ASHE ALTOONA/ PENNDOT 9-0 WORKSHOP

CONSTRUCTION UPDATE

APRIL 23, 2026

Pennsylvania
Department of Transportation

ITEM 4659-0001 HIGH FRICTION SURFACE TREATMENT (HFST) BLACK

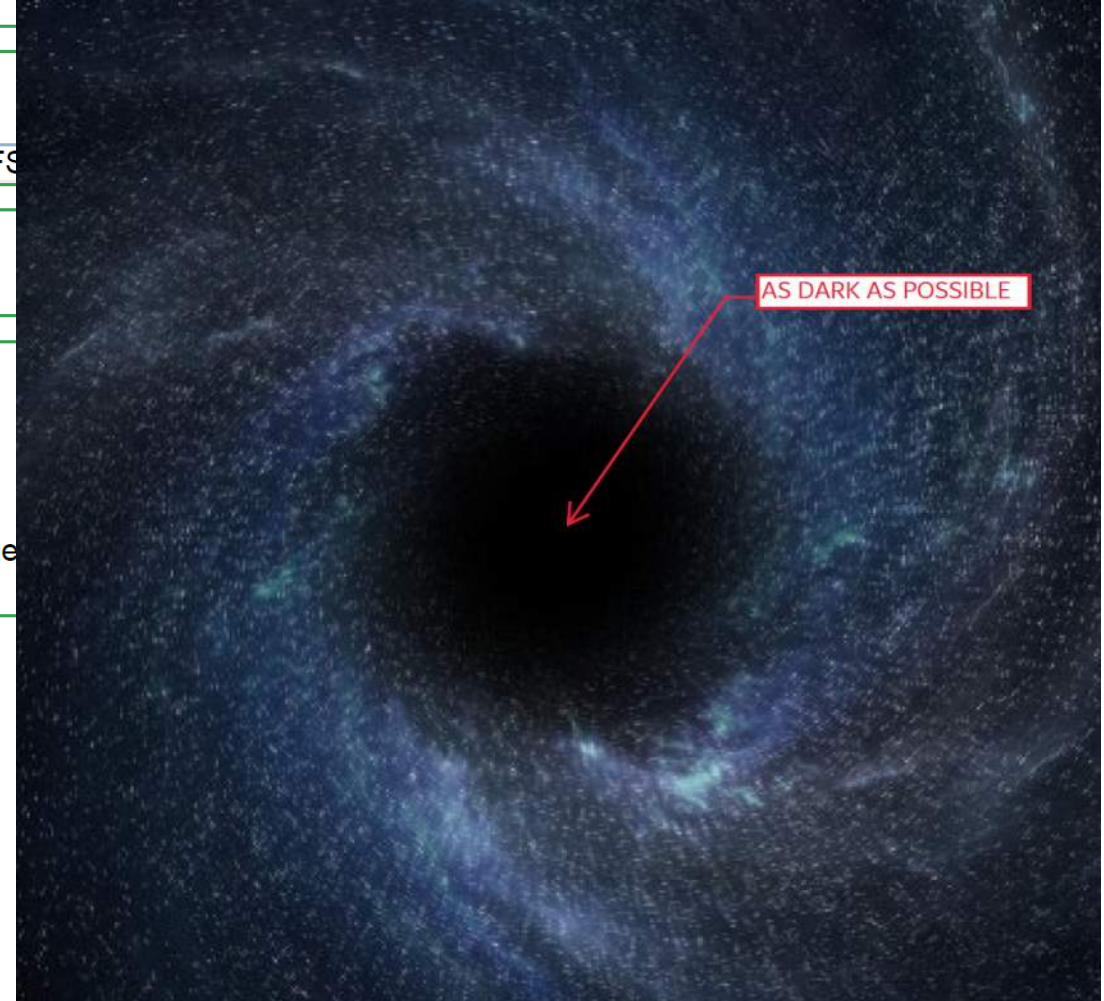
What exactly is *'the darkest color possible'*?
